State of Alaska DOT&PF
ALASKA STANDARD PLAN
MASH 3-TUBE BRIDGE RAIL
THREE BEAM TRANSITION

STANDARD PLAN DEVELOPMENT REPORT (SPDR)

Standard Plan No.: G-33.01

Title: 3-Tube Bridge Rail Thrie Beam Transition

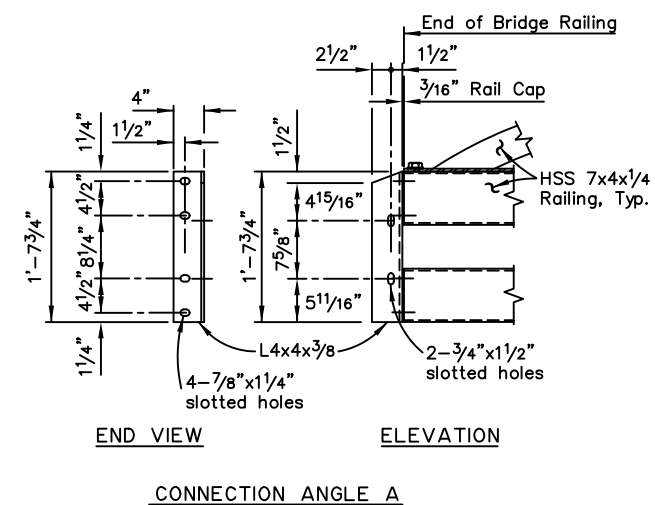
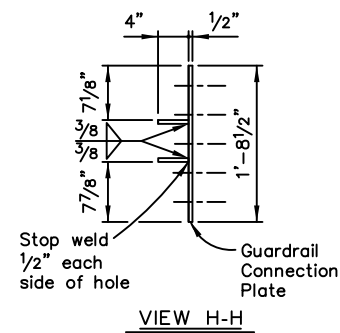
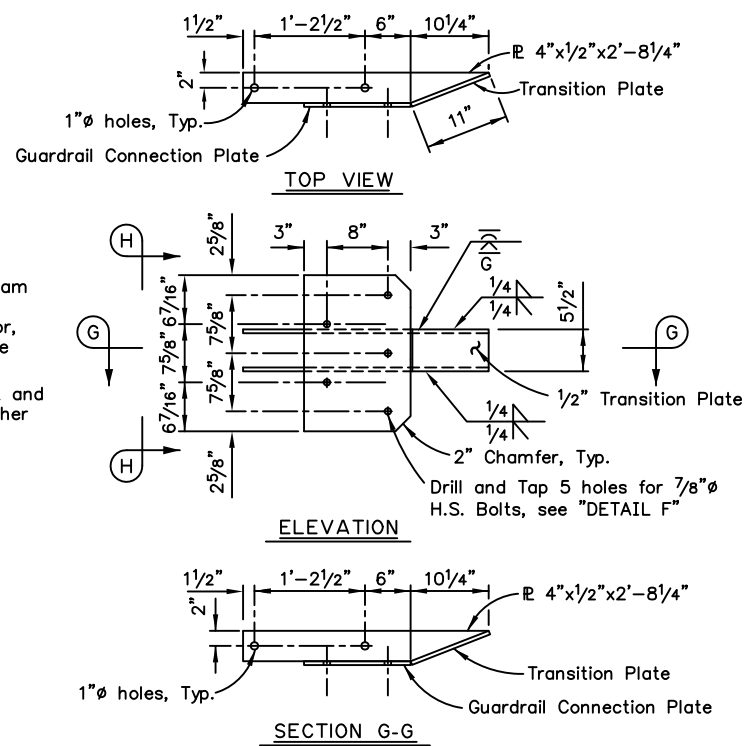
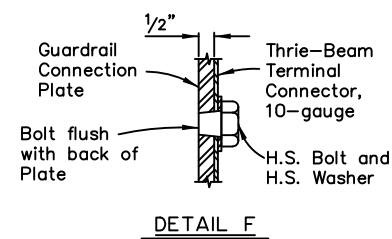
History: G-33.01 is the 2nd version of the Alaska Standard Plan and contains corrections to G-33.00 that ensured the Alaska Standard Plan matched the MASH 3-Tube Bridge Rail Thrie Beam Transition configuration and materials that are being used in construction, including a change to the “Task Force 13 Guide to Standardize Roadside Hardware” Thrie-Beam Terminal Connector and post size.

- “W6x9 Post” callouts were changed to “W6x8.5 Post” for all posts.
- “2 – 1’-2” Guardrail Bolts” was added to the Thrie Beam Steel Blockout – Long detail for clarity.

- “1 – 5/8 x 1 ½” Hex Bolt on top and 1 – 1’-2” Guardrail Bolt on bottom” was added to the Thrie Beam Steel Blockout – Short detail, and lines indicating such bolts were added, for clarity.

- The callout for the “Transition Plate” was changed to “1/2” Transition Plate” on the Elevation detail of the Guardrail Connection Plate Details.
- “Alternate 2” was deleted from all the Thrie-Beam Terminal Connector callouts and details were changed to show the Thrie-Beam Terminal Connector drawn as Alternate 1.

- Note 3 was added and the callout for the Elevation above was moved and added as Note 4.
- “Rail Cap, see “Rail Cap Detail” on “Steel Bridge Railing, 3-Tube” Dwg.” callout on the Connection Angle A Elevation detail was deleted.

- “See “Plate D” Detail on “Steel Bridge Railing, 3-Tube” Dwg.” callout was deleted from Section E-E.
- The dimensions for the vertical holes in the bridge rail tube, in the Transition Connection – Elevation and Section E-E were deleted.

- The 3/16" Rail Cap dimension was moved to the Connection Angle A Elevation view.
- A clarification was added to the callouts for the post View A-A and post View C-C, for hole placement.

- Post details were rearranged to match placement in the Plan view.
- The "No Backup Plate required, Typ." callout was moved to an appropriate post.
- The bolt callout note on Section E-E was changed to match capitalization of the same note on the Alaska Standard Plan G-32.04 and the Plate D callout note was deleted.

- The 'Limits of Bridge Railing for Payment' was added, and the arrows were revised.
- Guardrail Bolt specifications were added to the callout on the Transition Connection – Elevation detail.

- "self locking Nut" was removed and "Hex Nut" was added to the callout on the Section E-E detail.
- Section H-H was corrected to View H-H.
- Drafting cleanup of some lines was done to the Elevation view, along with other minor drafting corrections, including double dimensioning throughout.

- The dimensions were updated in the Plan view for the "End of Bridge Rail" to the first Transition Rail post and the "End Rail Post" post spacing to the "End of Bridge Rail" dimension was deleted.
